City of Valdez

Planning Department

**Replat #: 19-06**

I have completed a zoning review for subdivision application #19-06, a replat of 126 and 112 Pioneer Drive, Lot 1 and Lot 2, Slim Blood Subdivision Addition #2 (plat 79-4.) Application #19-06 is for the addition of a 50 foot portion of Lot 2 to Lot 1. Both lots are in the central business district. There are no minimum lot size or lot width requirements in the central business district per VMC 17.28.060.

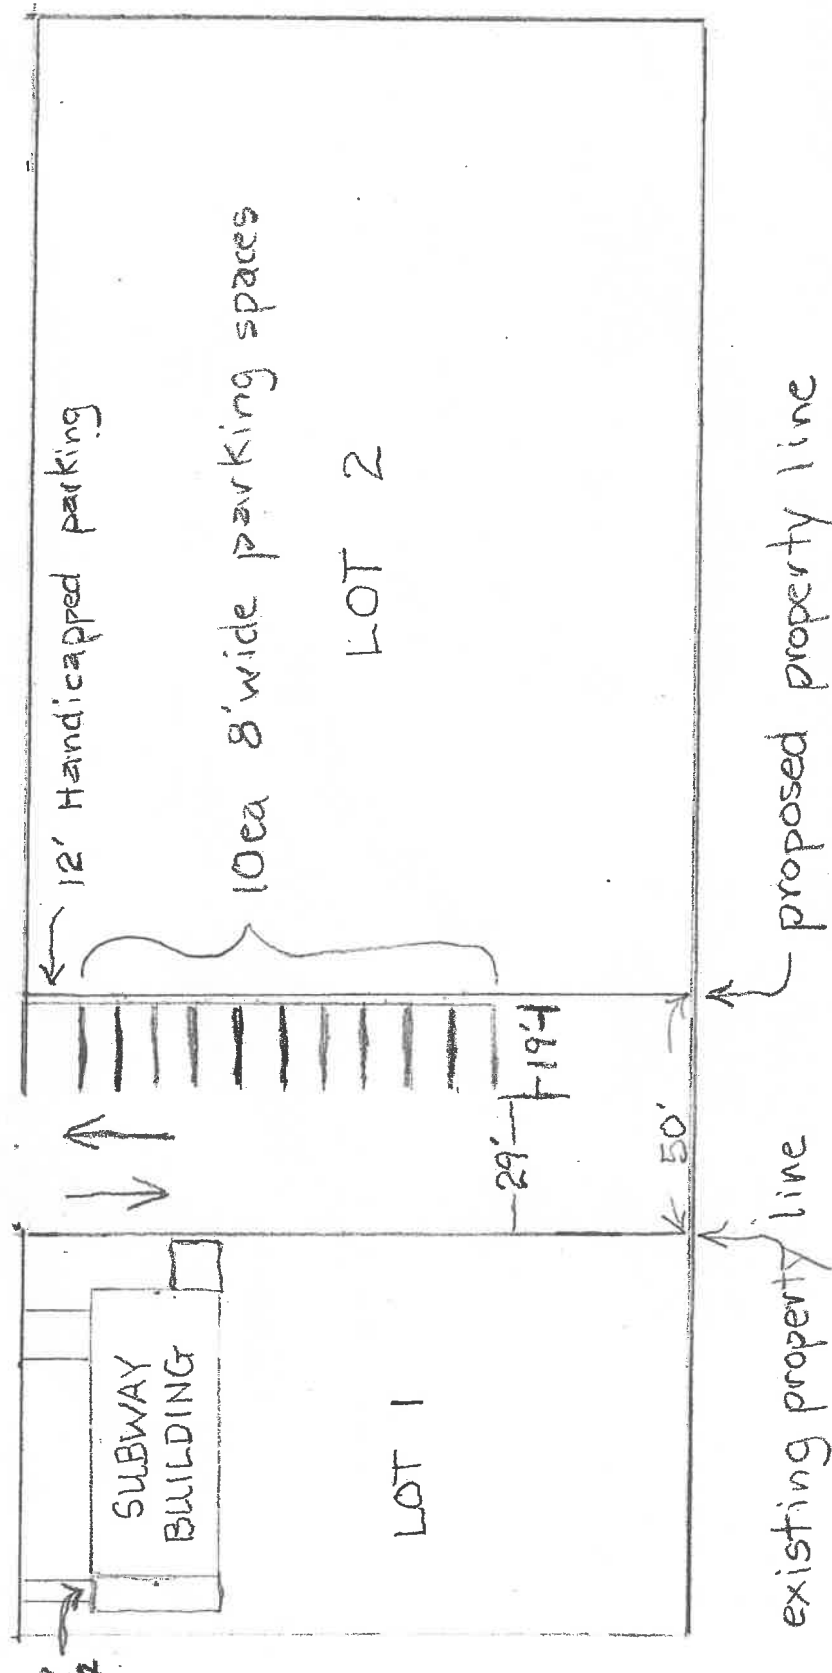
Based on this requirement, per the site plan submitted by Mr. Blood, the number of parking spaces required would either be 5 based on floor area, or 16 spaces, based on maximum seating capacity. In this case, the minimum parking requirement of five spaces has been met.

After reviewing the parking plan submitted by Mr. Blood, I have found that the proposed parking plan meets Valdez Municipal Code parking requirements for the current use. In addition, this lot line adjustment will not create any zoning violations if approved.
